PUBLIC NOTICE
CITY OF BEXLEY
ARCHITECTURAL REVIEW BOARD

- a. Application No.: ARB-19-24
Applicant: William T. Gruber & Dean Wenz
Owner: William T. Gruber
Location: 745 Francis Avenue

ARB Request: The applicant is seeking architectural review and approval to demolish the existing single-family dwelling, and allow a new single-family dwelling and detached garage to be constructed on the lot. Please Note: This application was tabled at the June 13, 2019 meeting of the Architectural Review Board.

The Gruber Residence
745 Francis Avenue Bexley, Ohio

KDG PROJECT # 2019-209	SHEET NUMBER
EXTERIOR ELEVATIONS - PROPOSED	A2-1
CONSTRUCTION DOCUMENTS	SCALE: 1/4" = 1'-0"
	11.27.2019

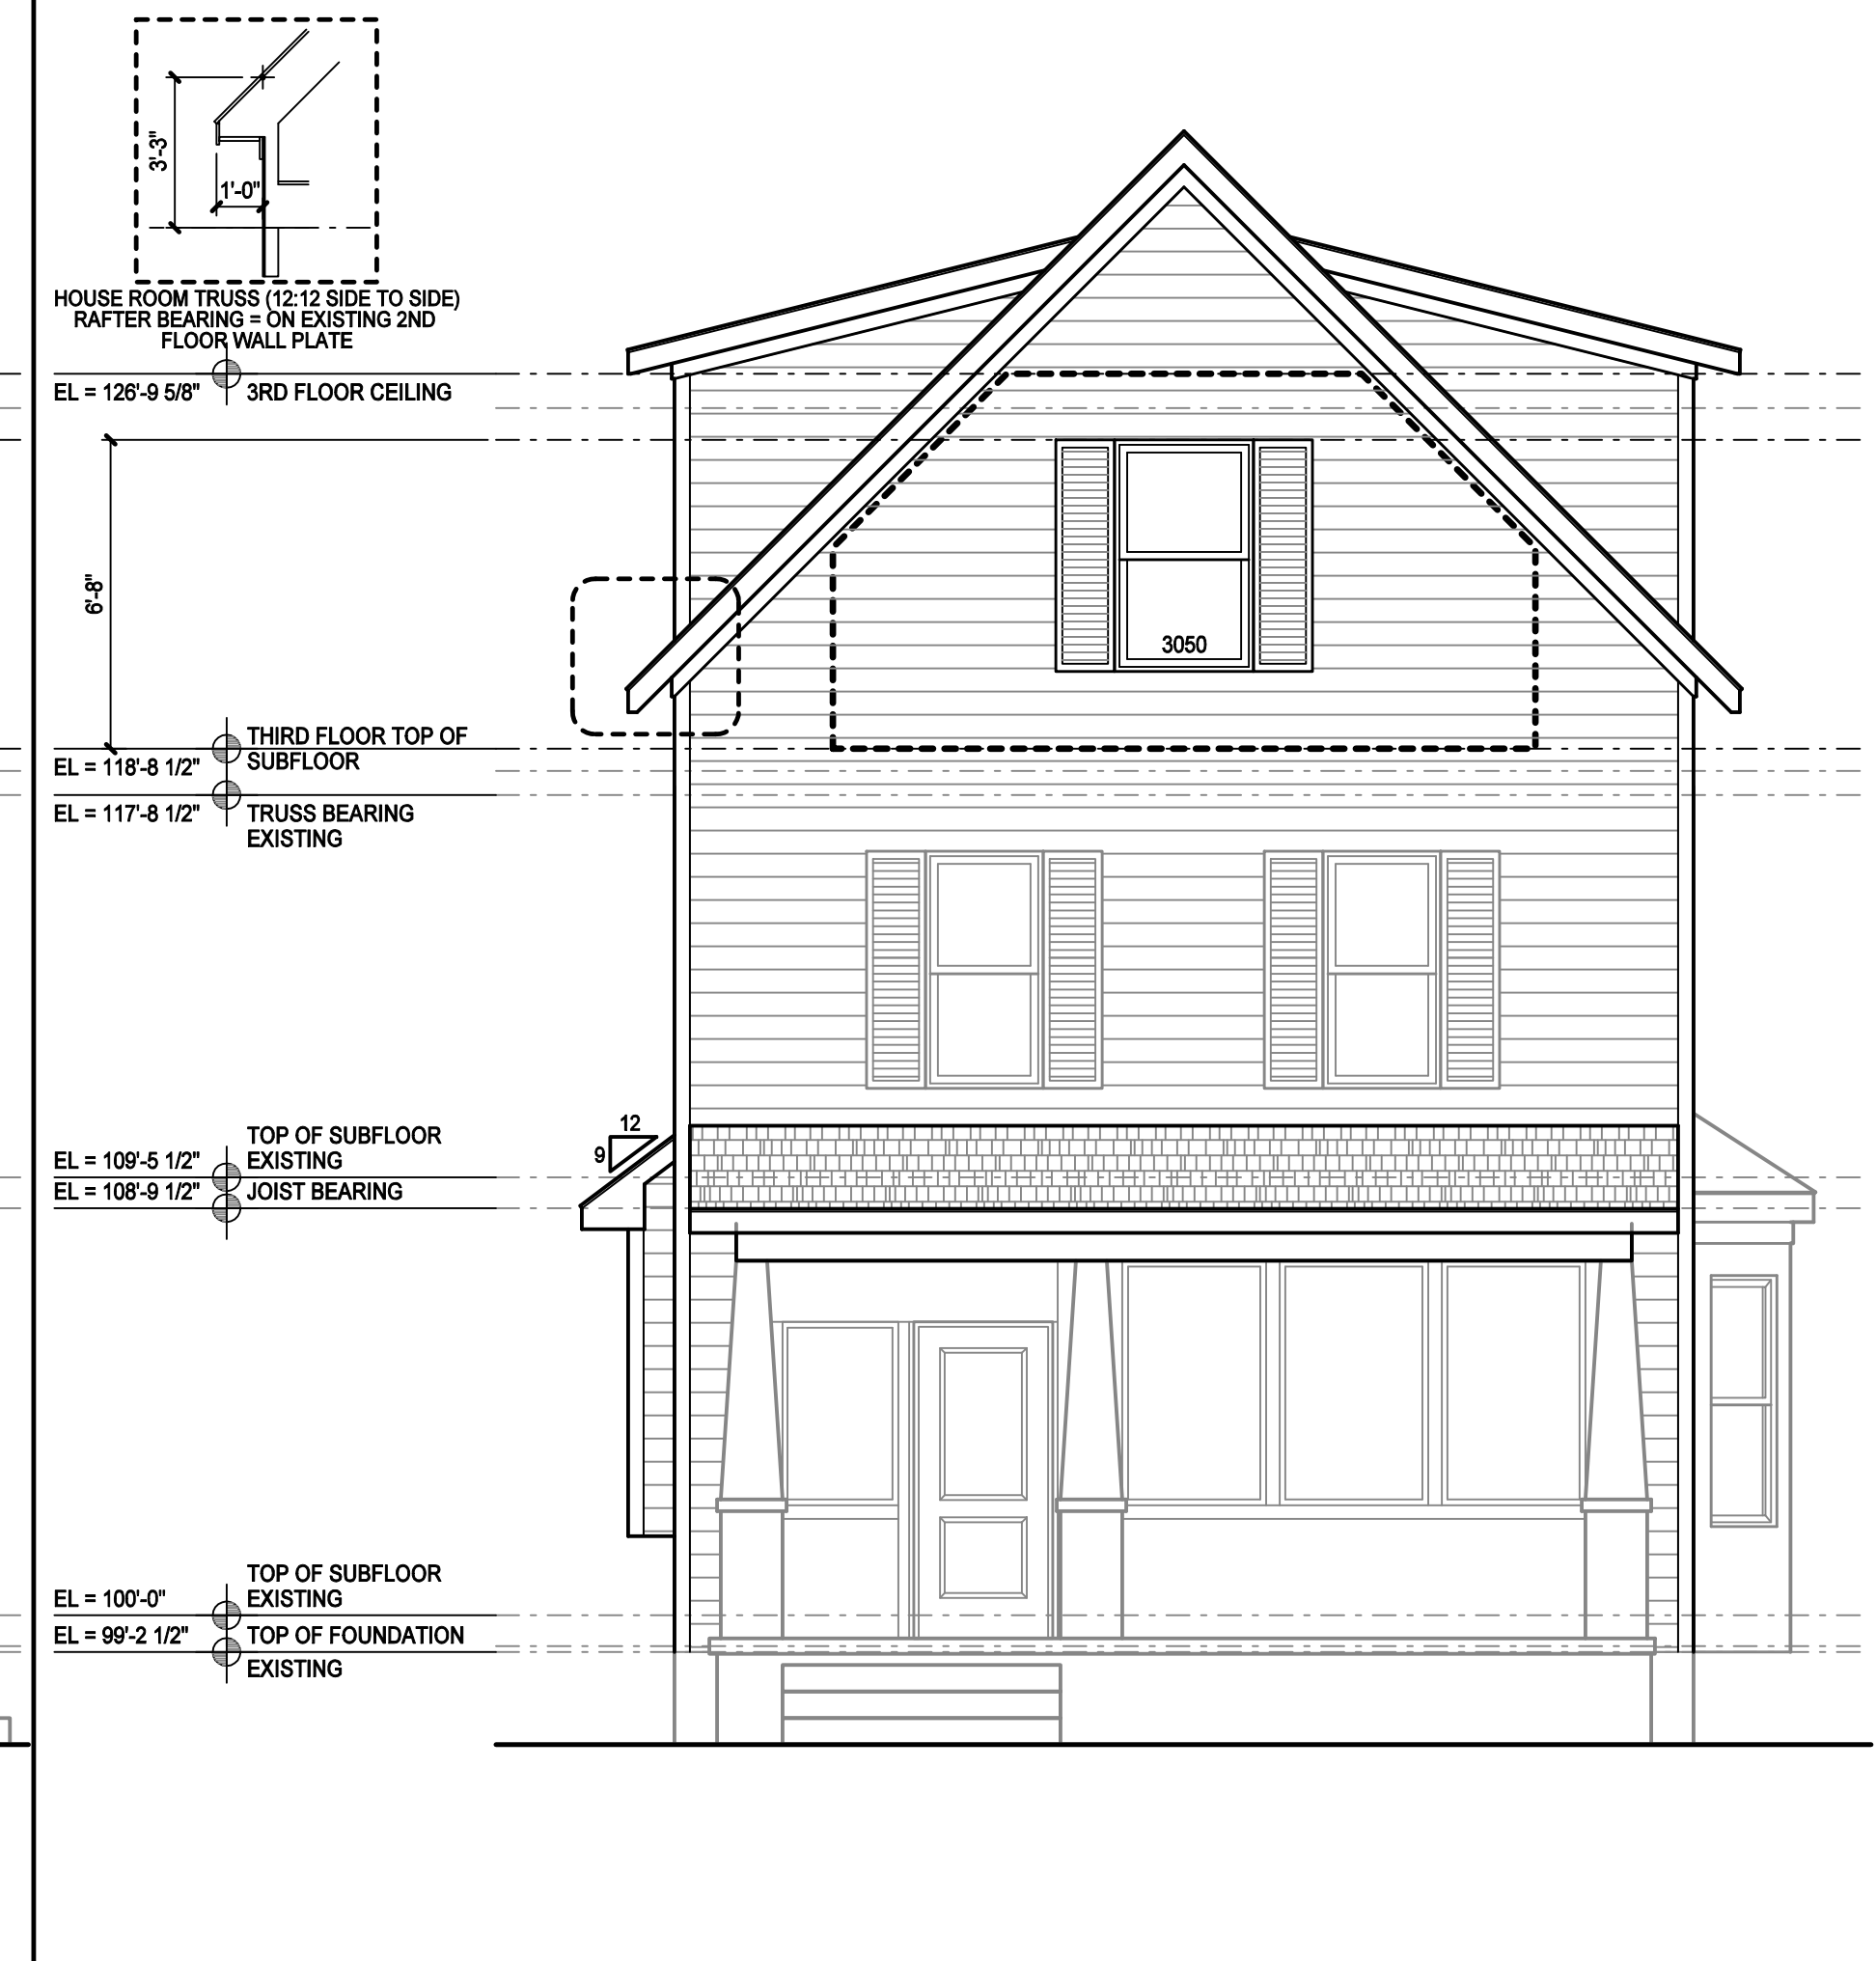
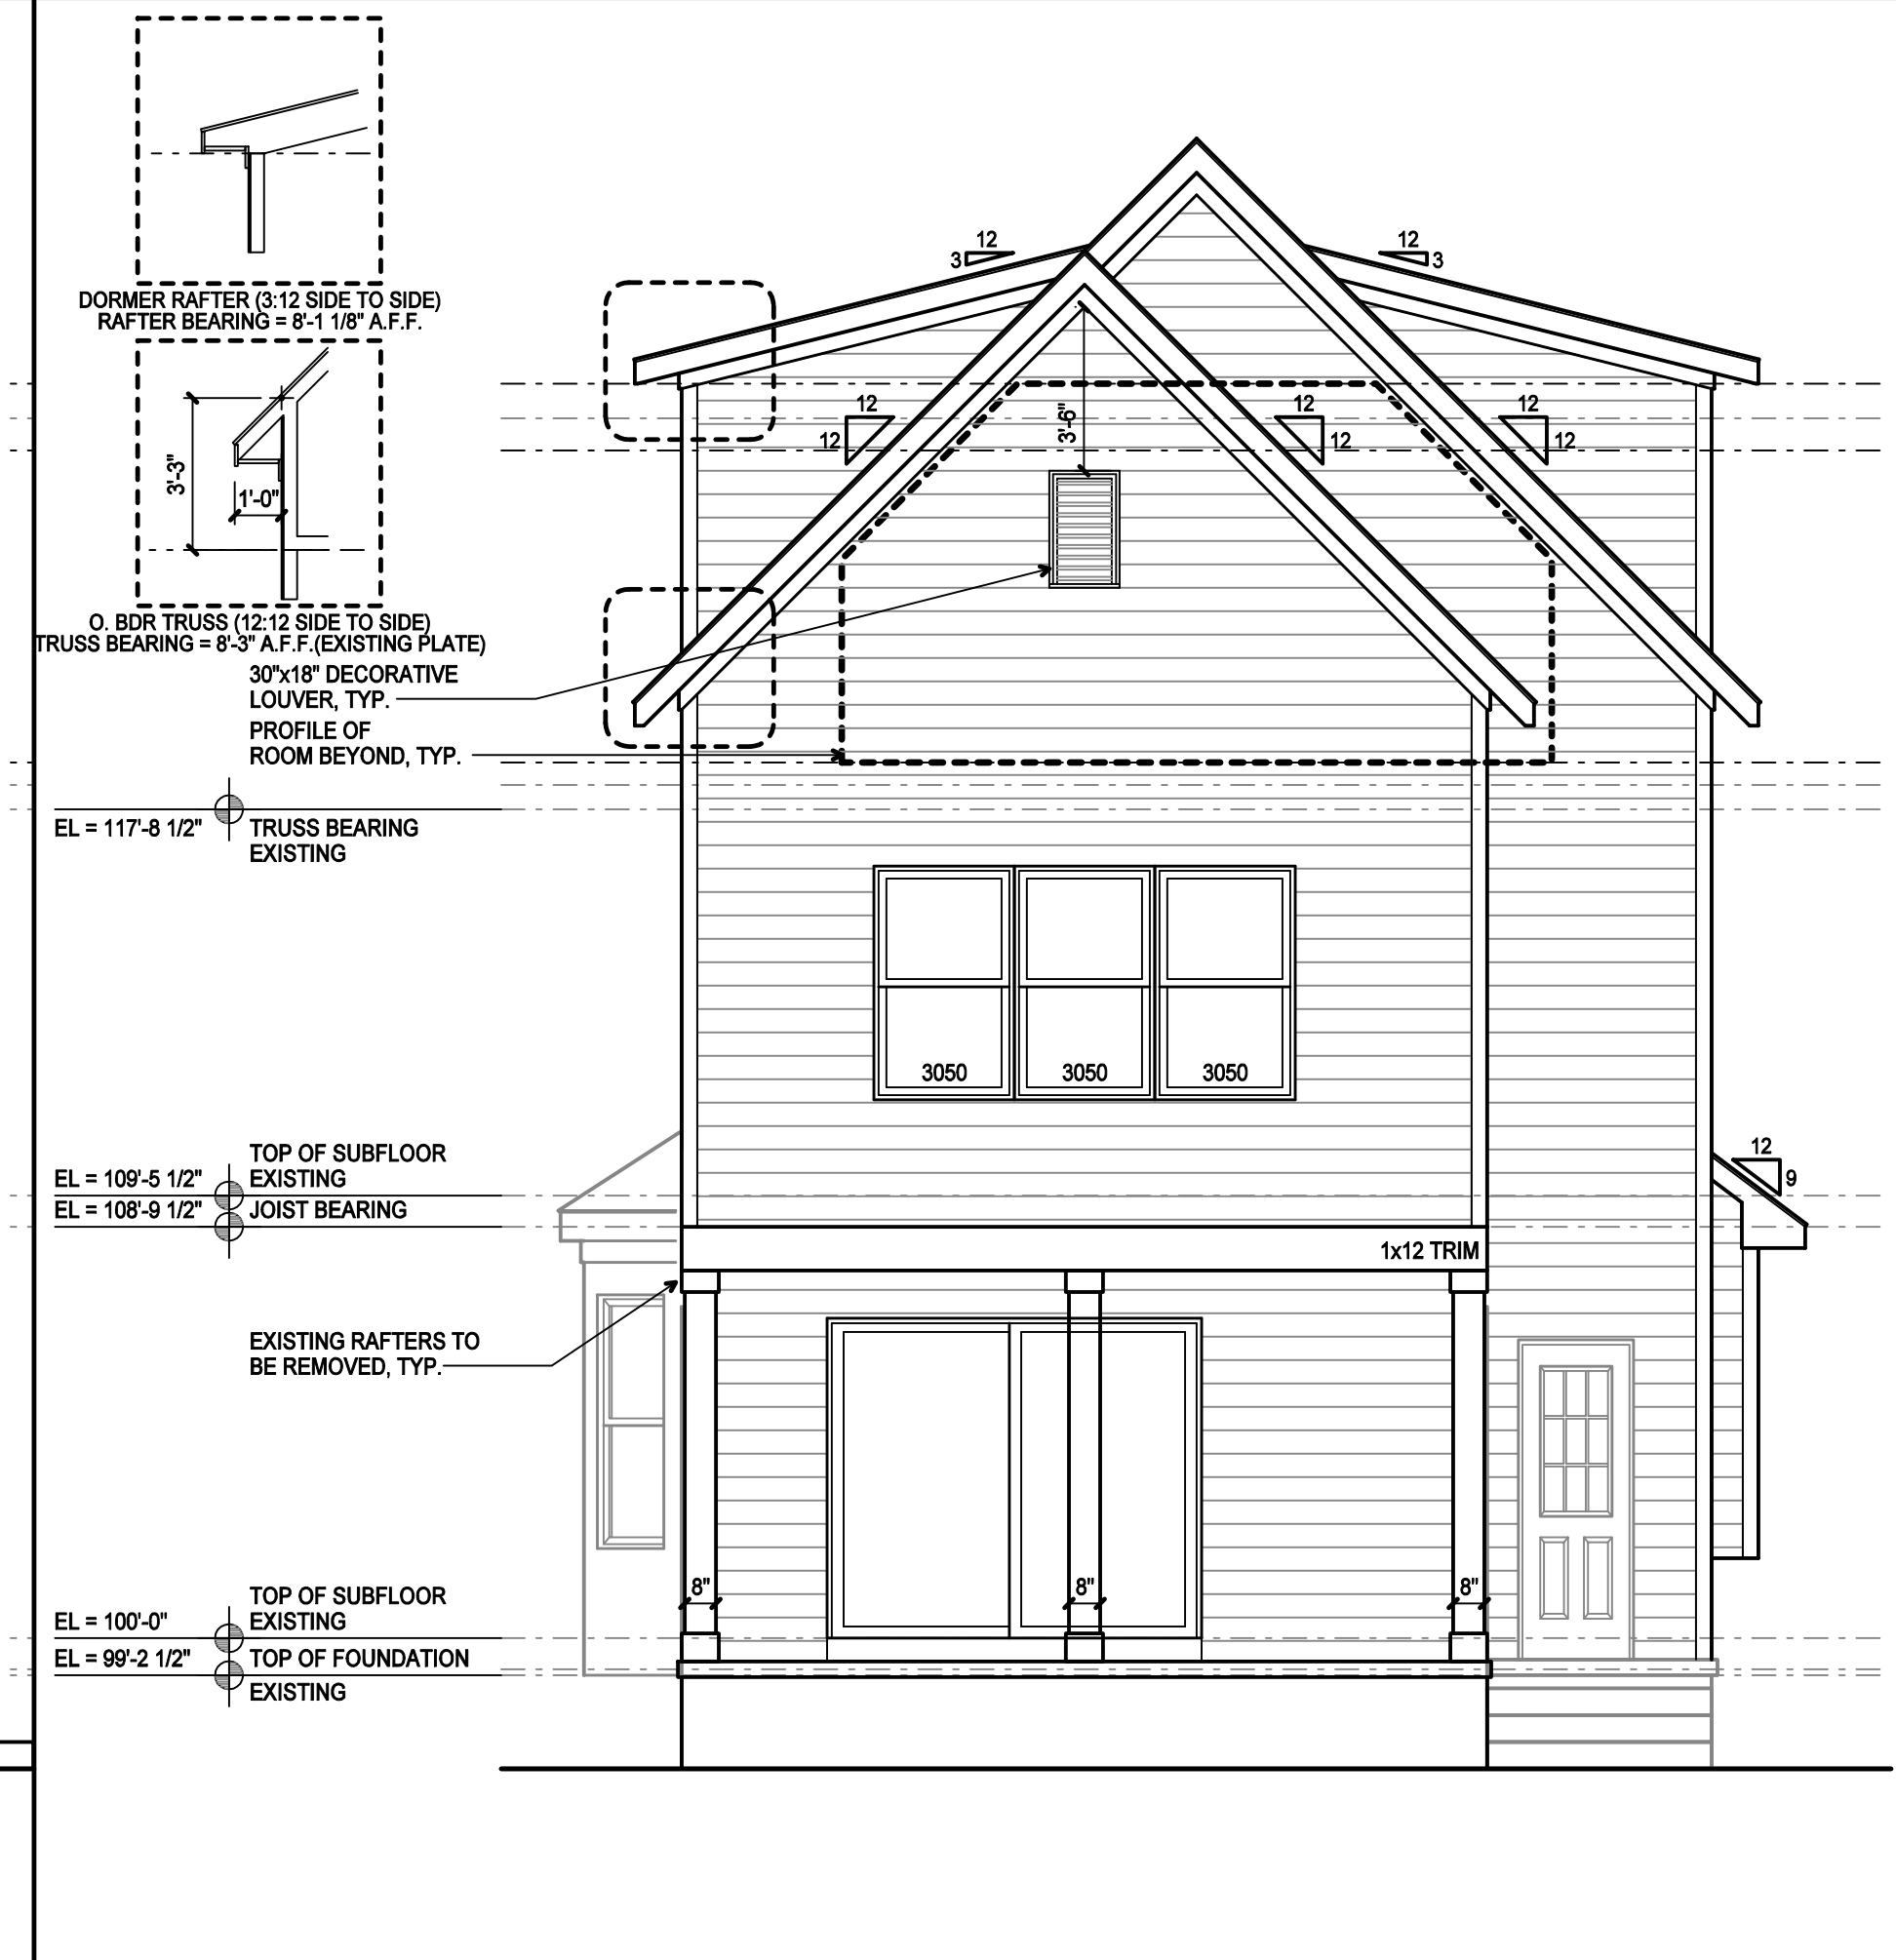
I would like a site plan to provide specific side yard setback of the existing structure uploaded - concern that adding on in-line with the existing structure is not the best option, especially due to the fact that you are increasing the height as well. What is the new ridge height?

Karen - this looks long and narrow and tall. There is a variance to extend to house at the same setback and they are raising the roof. You may want to take a look and critique what's proposed, in case there are any suggested modifications.

It looks like Dan Keiser did the plans ??? Let me know what I'm missing..... Also I think it looks good! The additional height is good.
